STREET A PLAN AND
PROFILE

PARKER RIDGE
82 SCHOOL STREET
ROLESVILLE / NORTH CAROLINA / 27571

08/01/2023 PER TOWN OF ROLESVILLE COMMENT

LONG MELFORD DRIVE PLAN
AND PROFILE (1 OF 5)

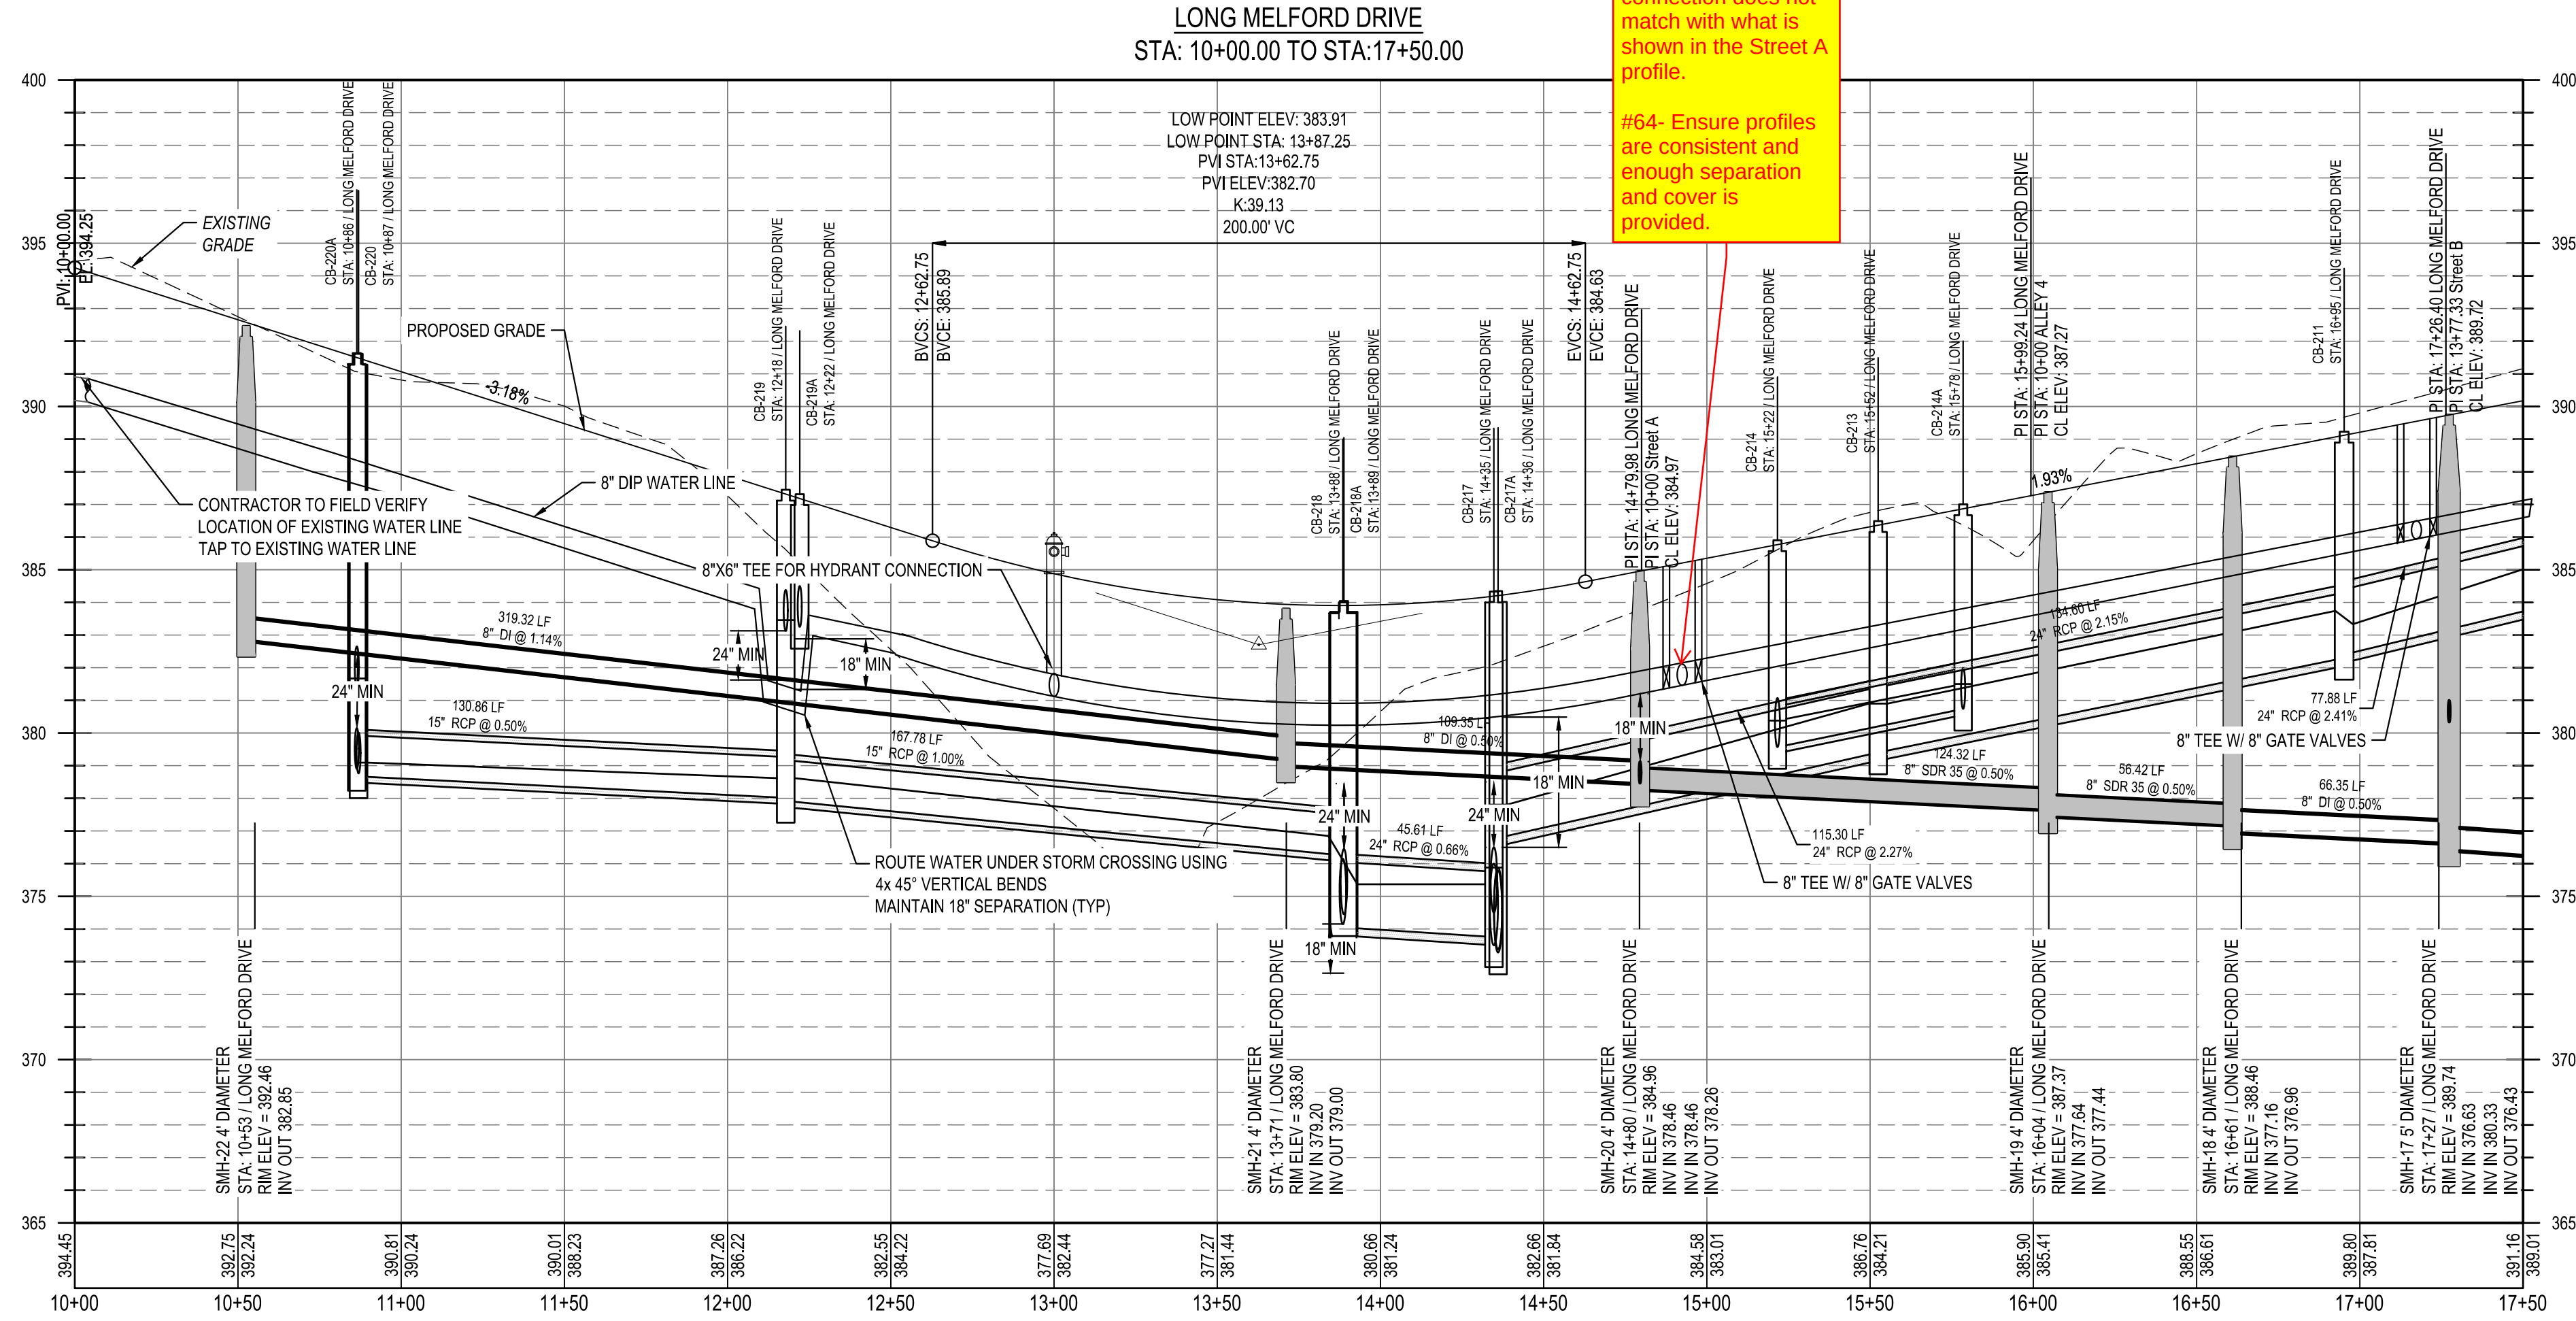
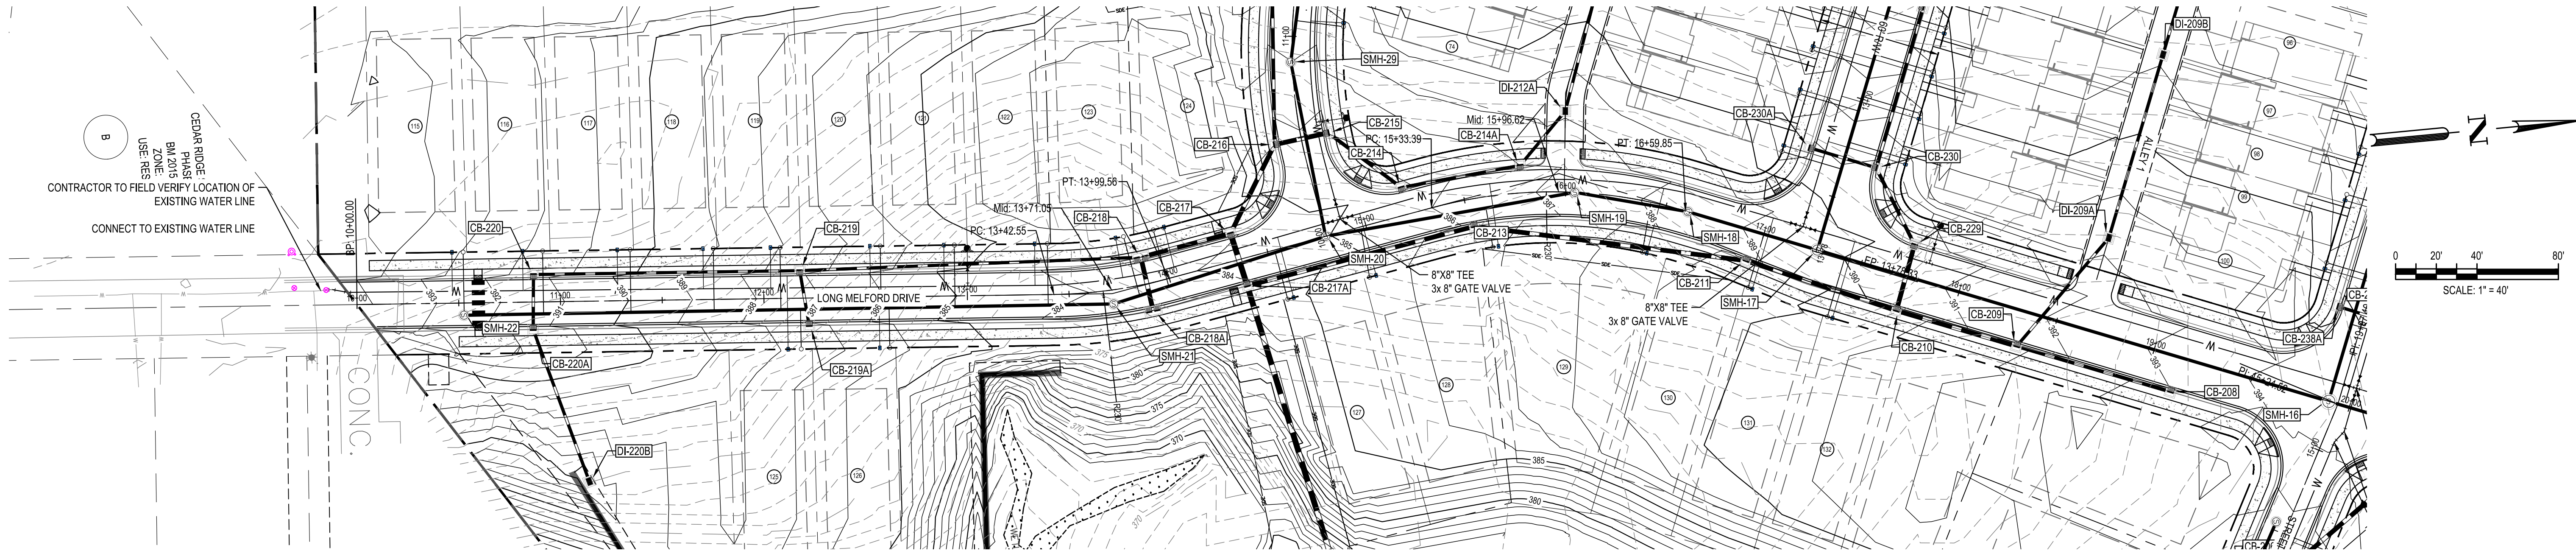
#63- Waterline connection does not match with what is shown in the Street A profile.

#64- Ensure profiles are consistent and enough separation and cover is provided.

#62- There are several locations where the dimensions don't seem to line up with top/bottom of pipes. Please make sure it is clear what is being dimensioned. If crossings are not meeting minimum requirements, design will need to be adjusted.
